MITIGATION PLAN

Revision #2

**UT West Branch Rocky River Restoration Site
Mecklenburg County, North Carolina
DMS Project Number 92684
DEQ Contract Number D16015i
USACE Action ID: SAW-2017-00342**

Re: NCIRT Review and USACE Approval of the UT to West Branch Rocky River Mitigation Plan;
SAW-2017-00342; NCDMS Project # 92684

Figure 1. Project Site Vicinity Map, UT West Branch Rocky River, Mecklenburg County, NC

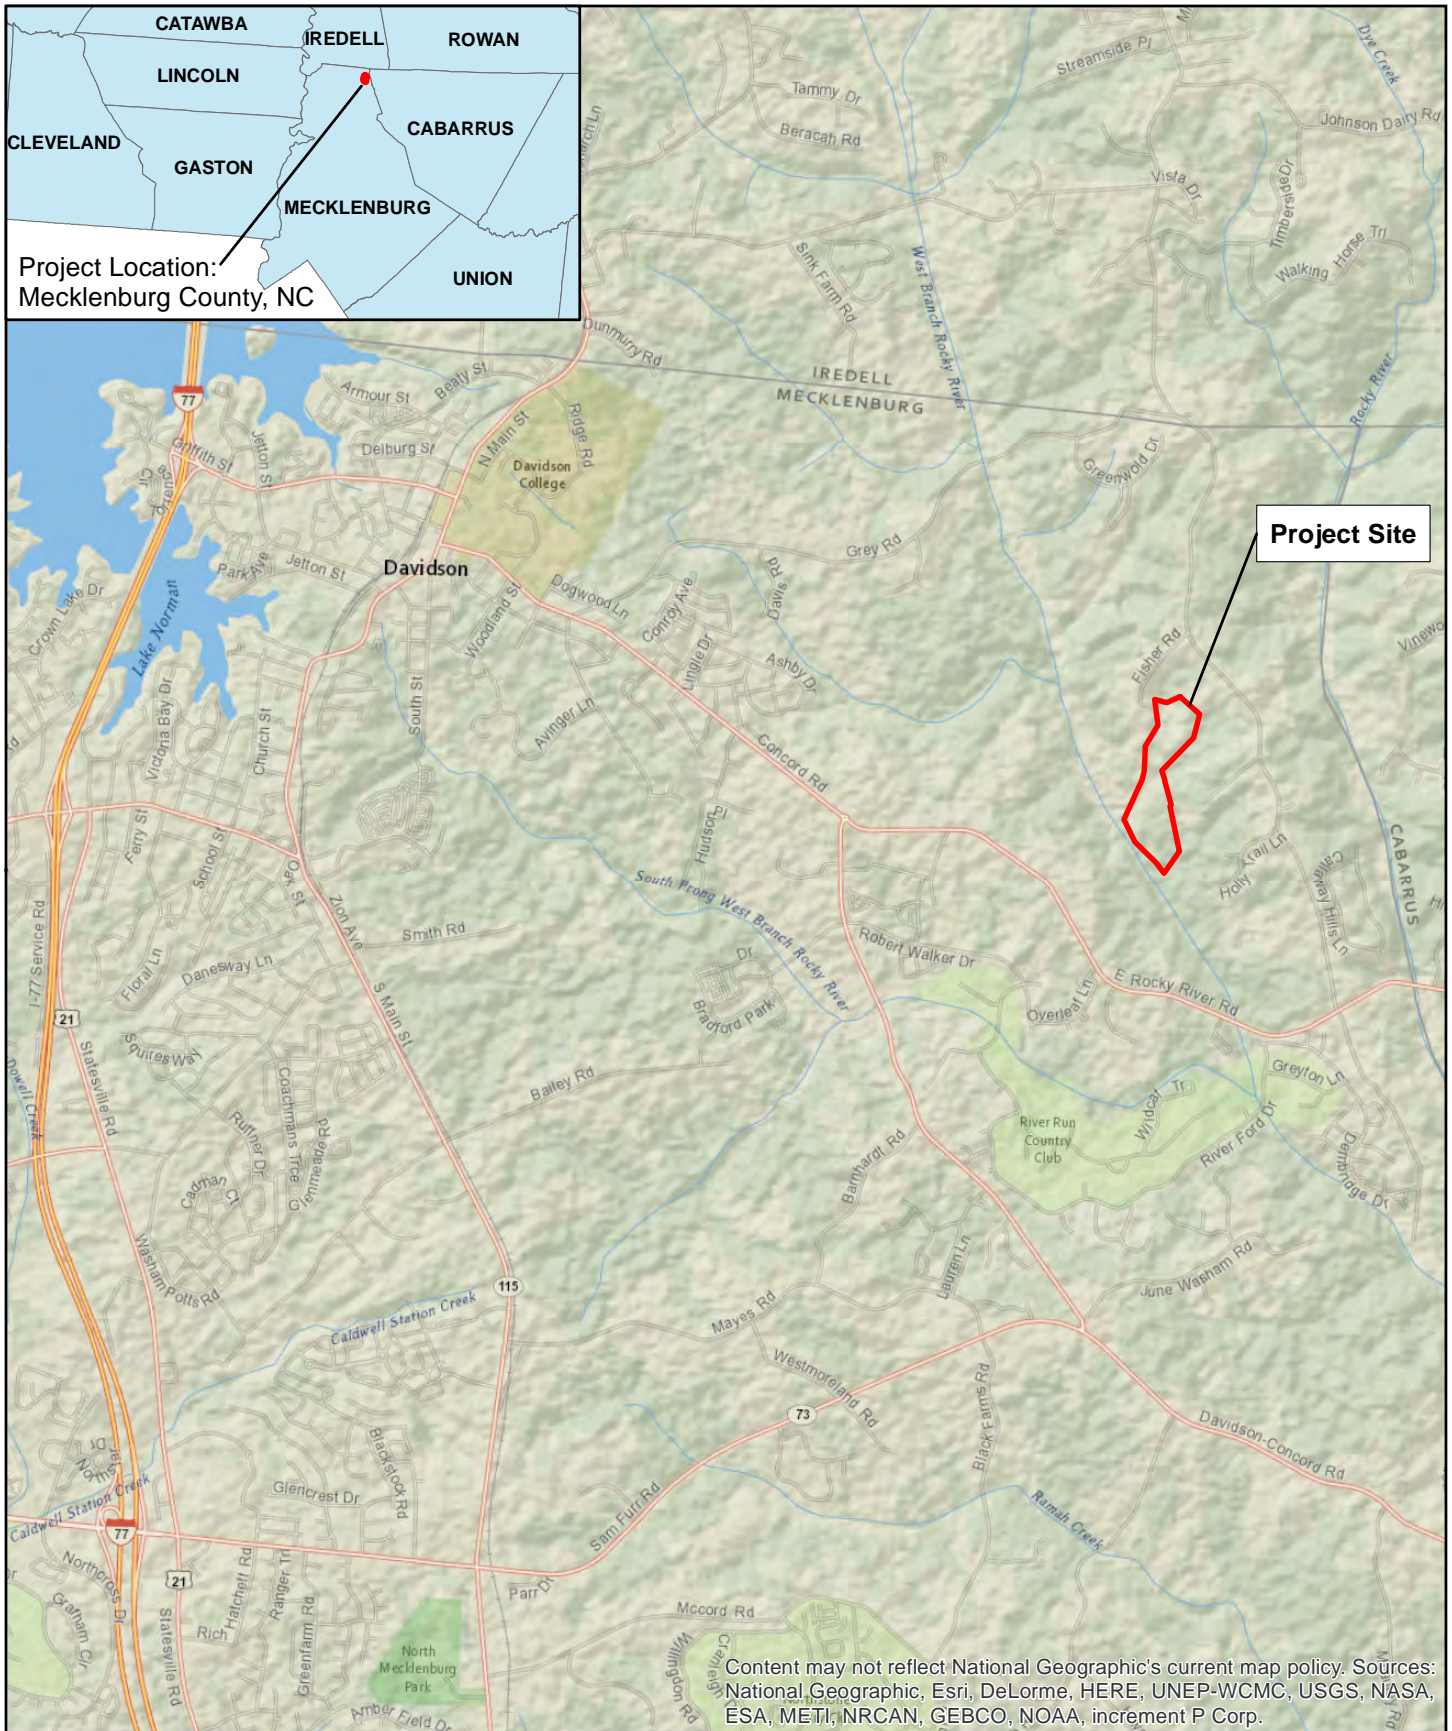
41. Figure 1 – Grainy texture; can this be improved? Stream names are barely legible.

Figure 7. Current Conditions Plan View Map, UT West Branch Rocky River, Mecklenburg County, NC

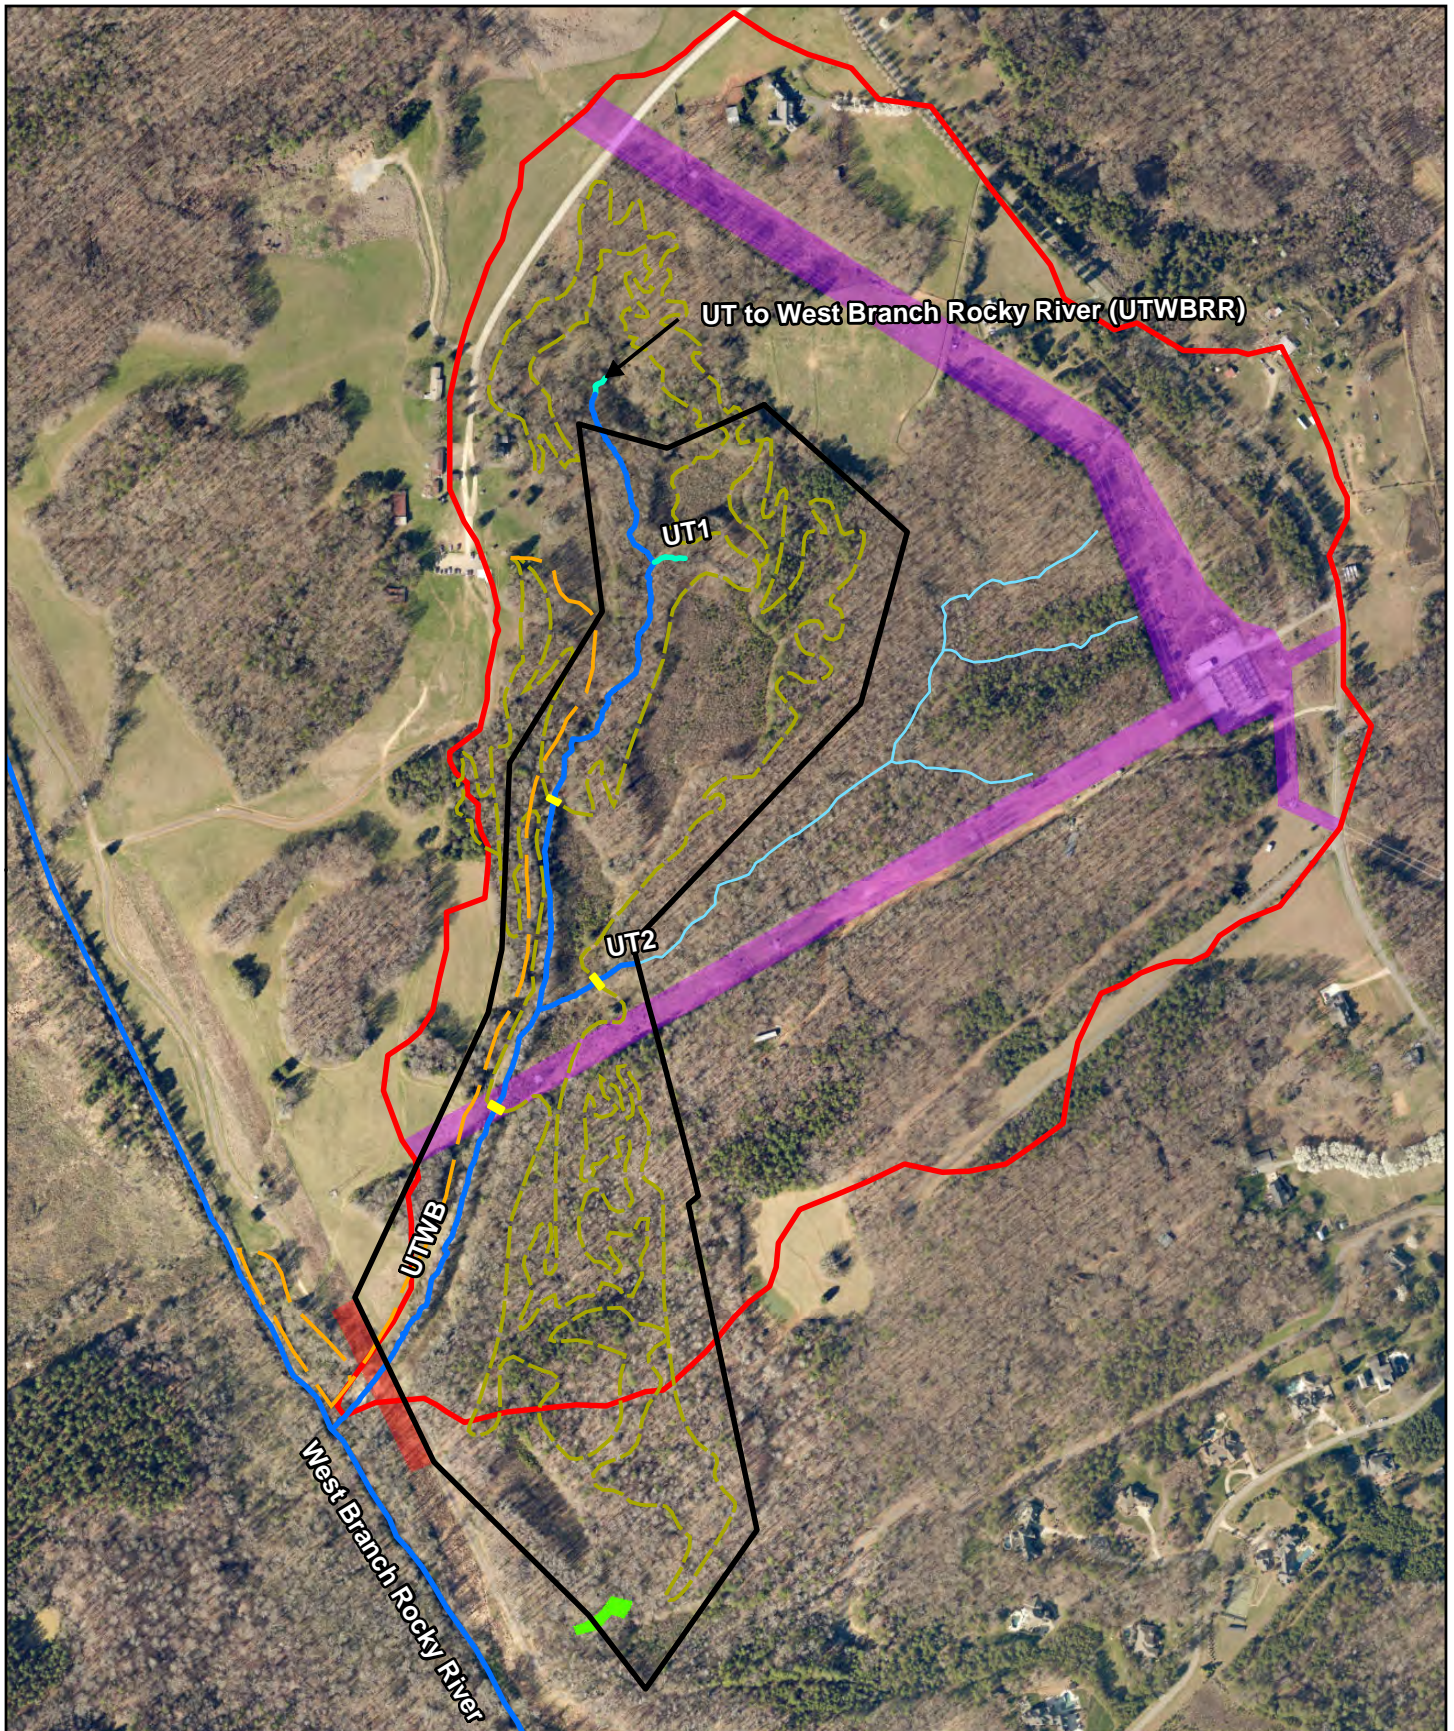
13. You must provide a legible map depicting all existing and proposed trails, greenways, and walkways within the credit generating boundaries for the site. Based on Figure 7, it appears that several trails will impact the stream buffer area but this is not depicted on the UTWB Stream Buffer Maps.

Figure 9. Cross-Section Schematic for UTWB-2 and UTWB-3, UT West Branch Rocky River, Mecklenburg County, NC

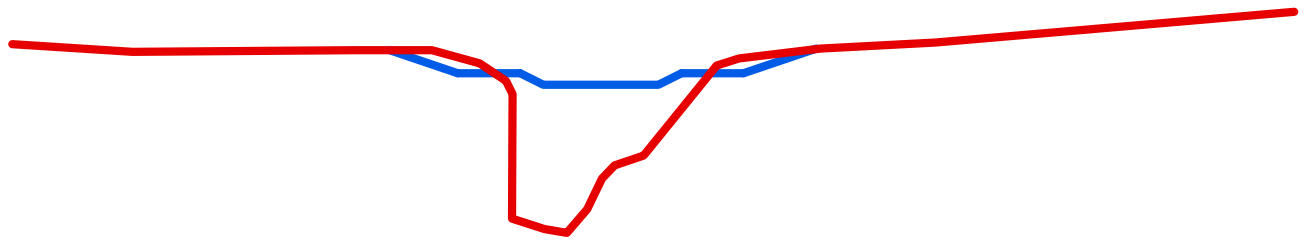
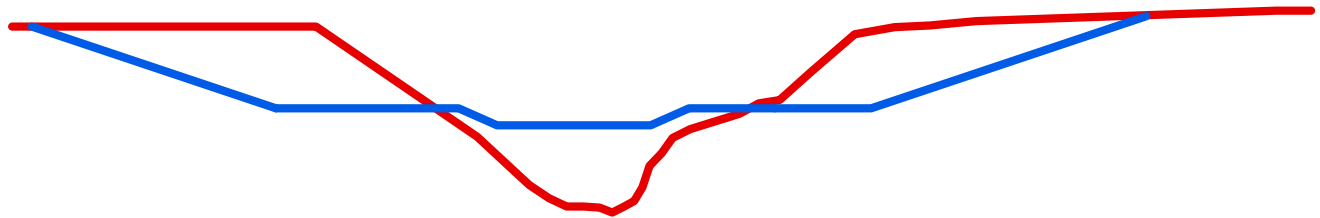
2. DWR likes the fact that macrobenthic monitoring will be performed on the project.
3. The cross sections shown in Figure 9 don't appear to show much of a channel. It appears that a floodplain is being graded across the valley.

A conceptual grading figure has been included as Figure 9. A more complete view of this will be included in the final construction plans, which will include grading extents on the planview sheets for Priority 2 reaches as well as detailed cross-sections with grading tie-outs shown.

Figure 10. UTWB-3 Proposed Priority 2 Approach, UT West Branch Rocky River, Mecklenburg County, NC

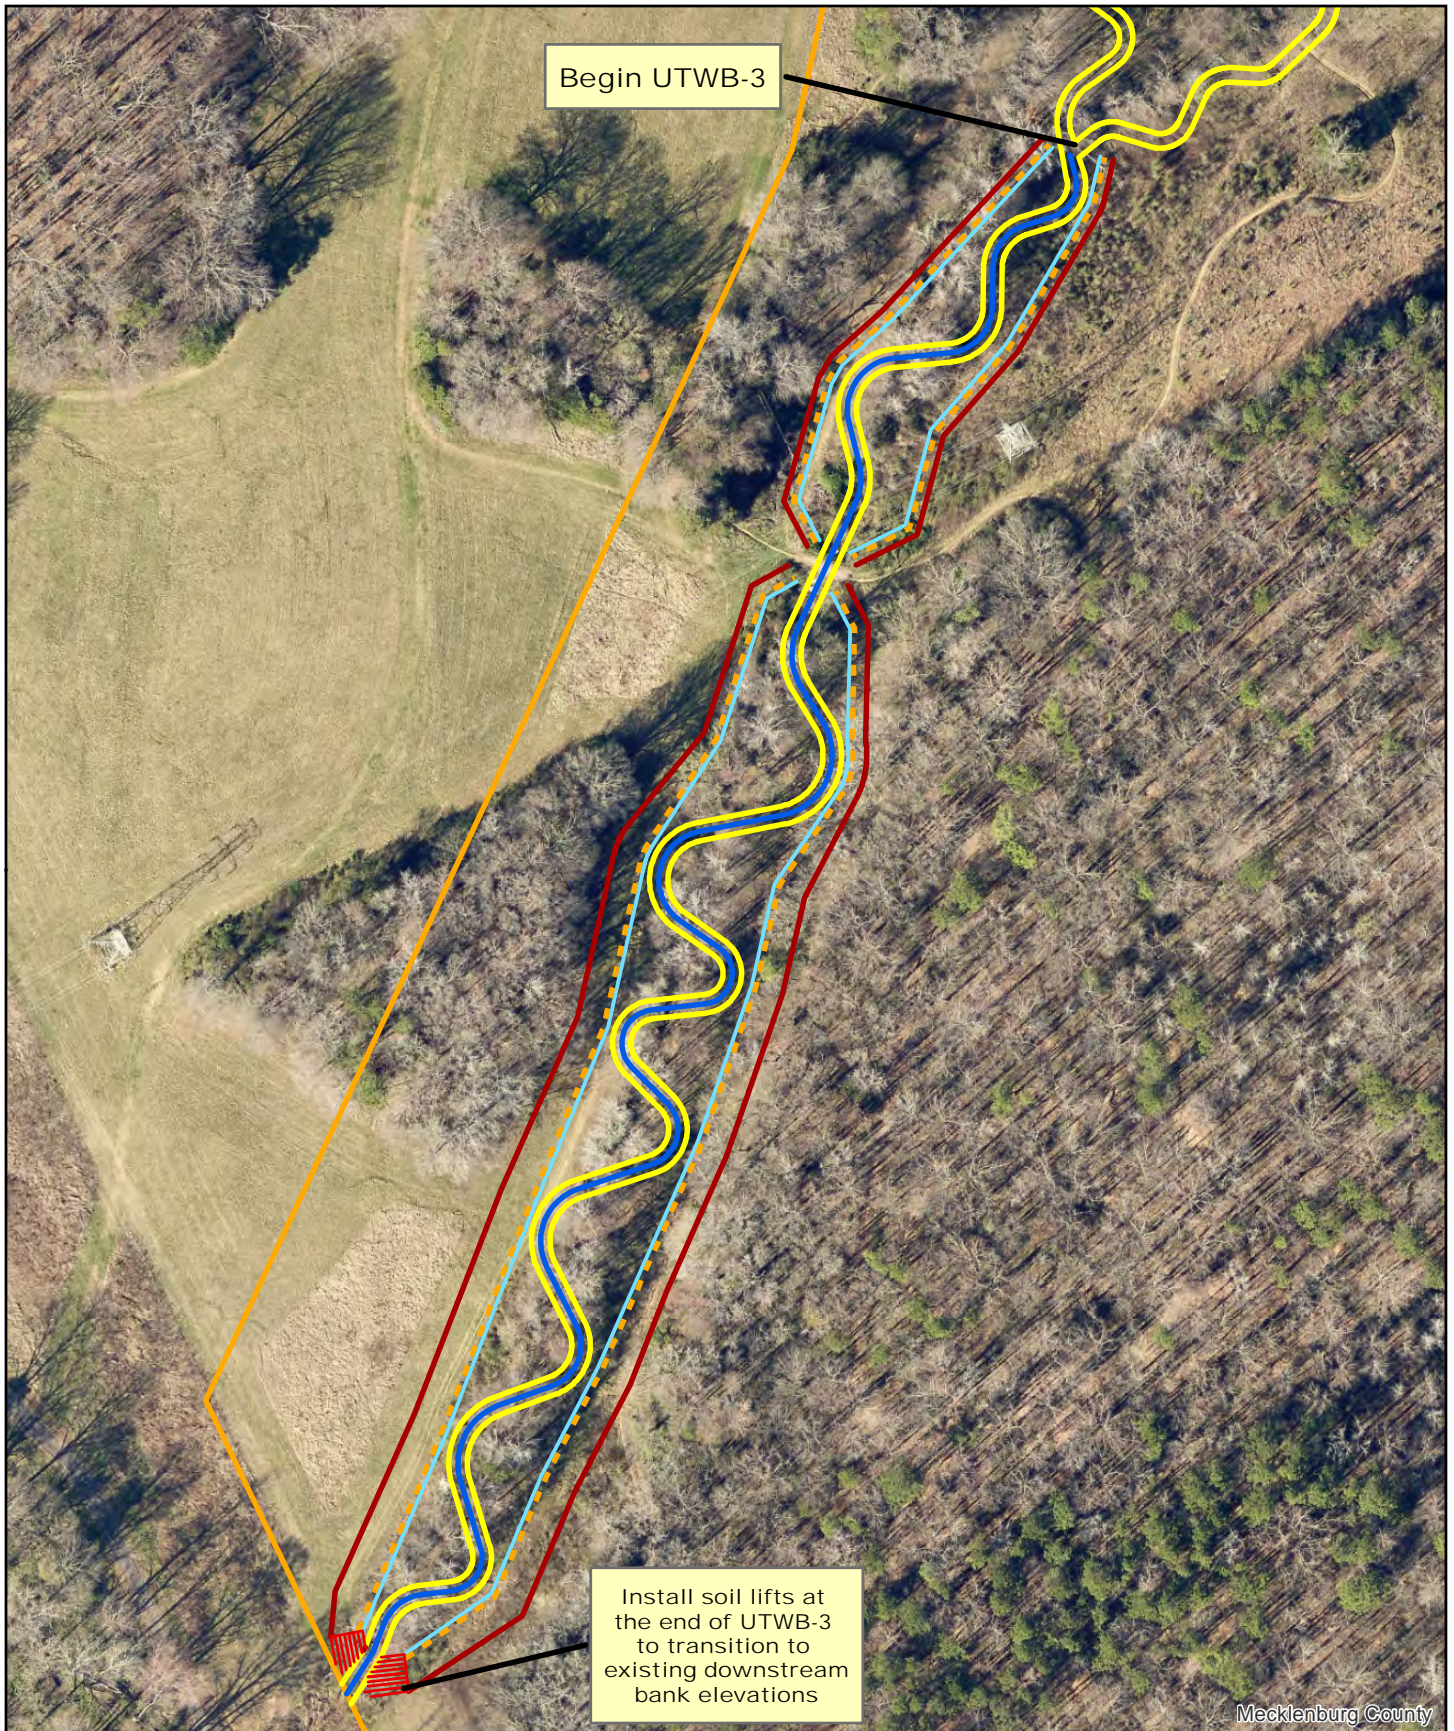
4. DWR also has concerns with the bench widths on reach UTWB-3 (as previously by DMS in comment #34 in their letter). DWR would prefer to see benching that is at least 2X bankfull width, with at least half of that on the outside meander bend where most of flow energy will be directed.

For UTWB-3, we included an additional diagram (Figure 10) that shows the extent of the floodplain grading. For all of UTWB-3, the entrenchment ratio is at least 2.2, and for the majority of UTWB-3 (excluding begin/end reach transitions), the floodprone width is approximately 50-90 feet wide. With the bankfull design width of 12 feet, this equates to an entrenchment ratio of 4-7.5. There are locations where the width of the floodplain on the outer bend is limited, but

Figure 12. Proposed Monitoring Plan, UT West Branch Rocky River, Mecklenburg County, NC

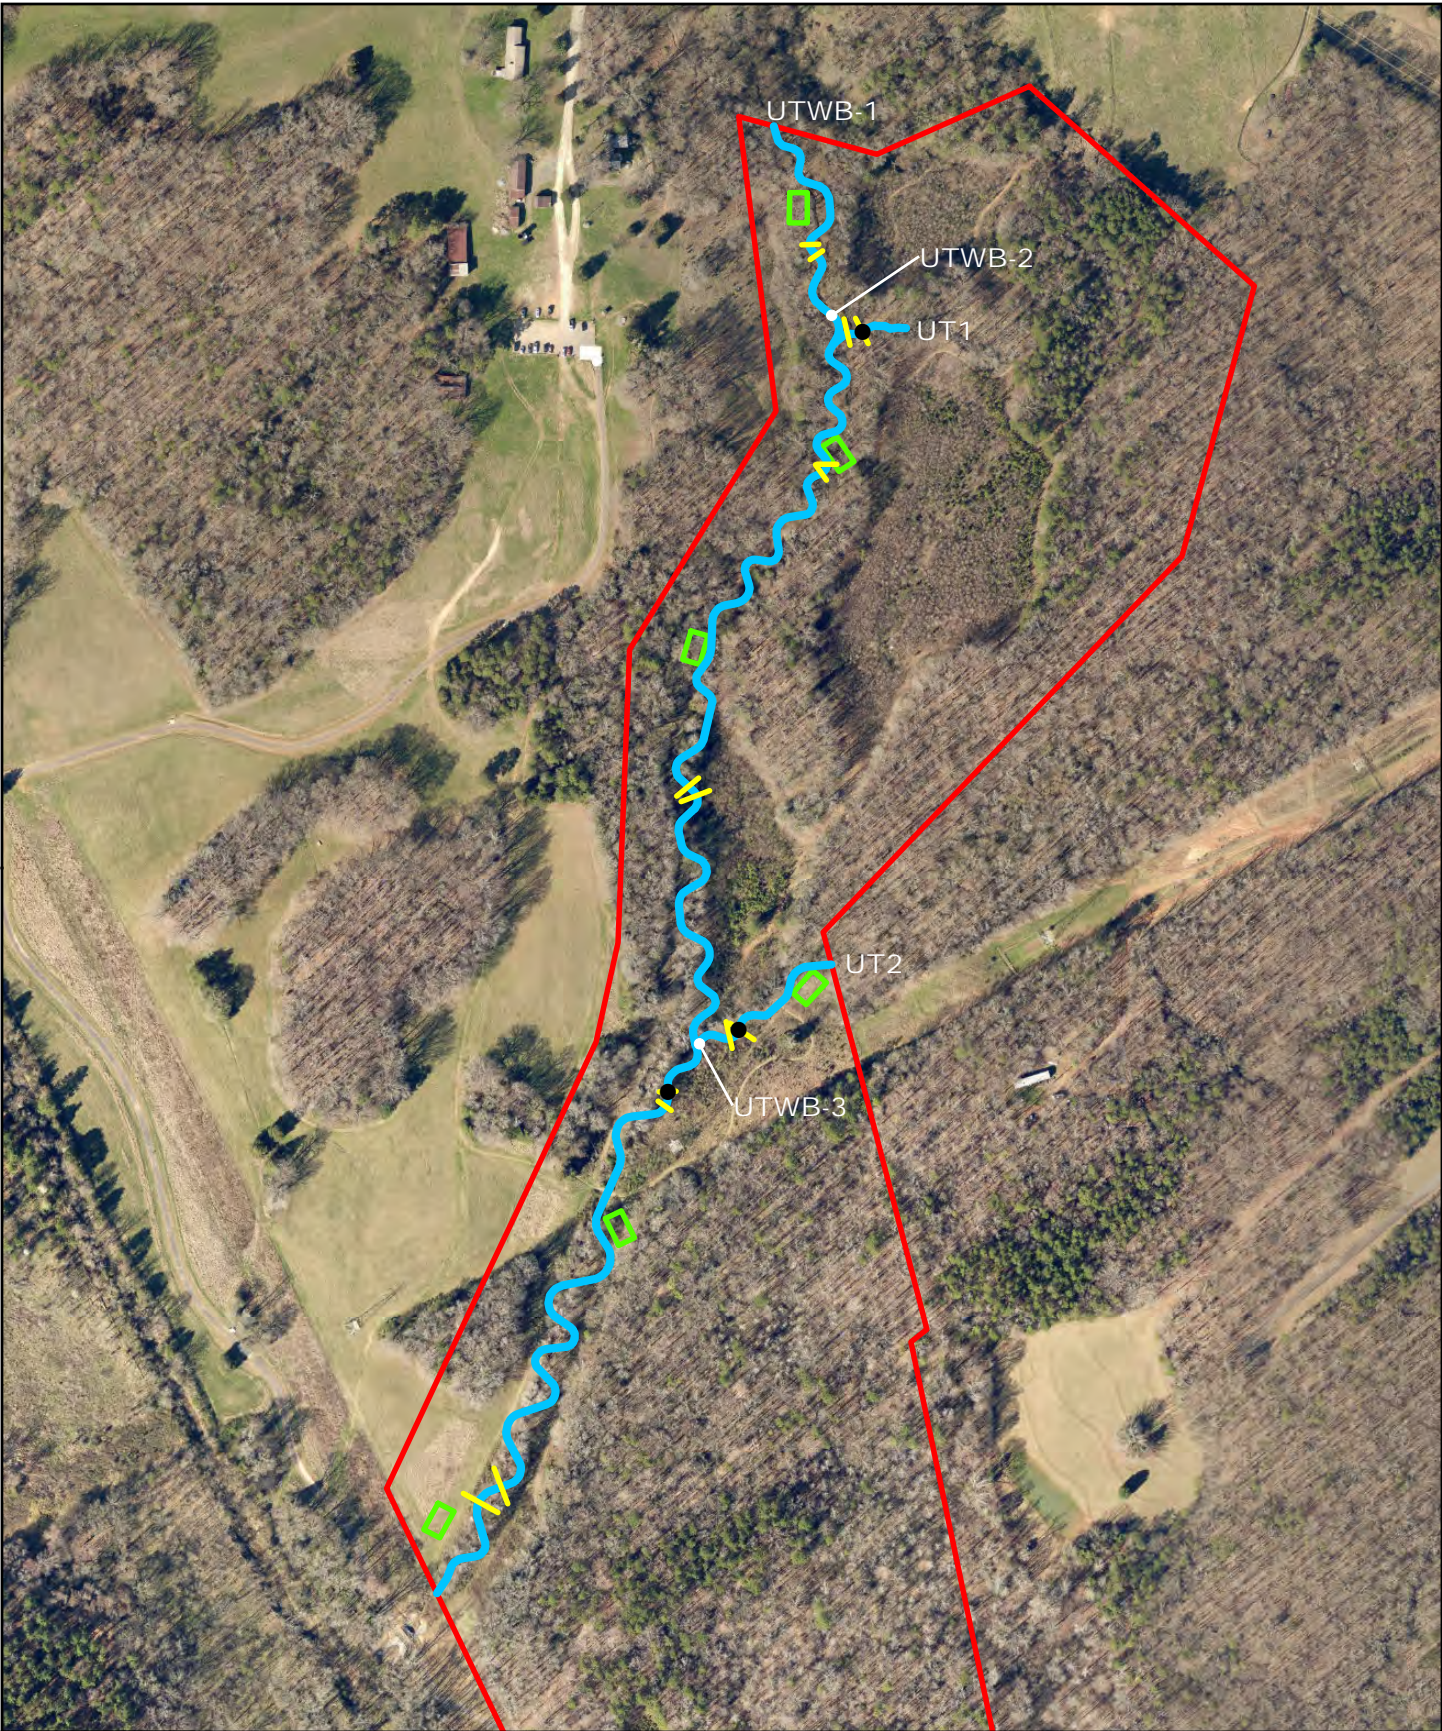
12. Figure 12/Page 39: Recommend moving the permanent vegetation monitoring plot at the project southern end into the adjacent agricultural field to be planted and outside of the 50-foot riparian zone. This will capture a former field and provide some monitoring for vegetation being used for additional buffer credit.

This plot has been moved as requested in the revised mitigation plan.
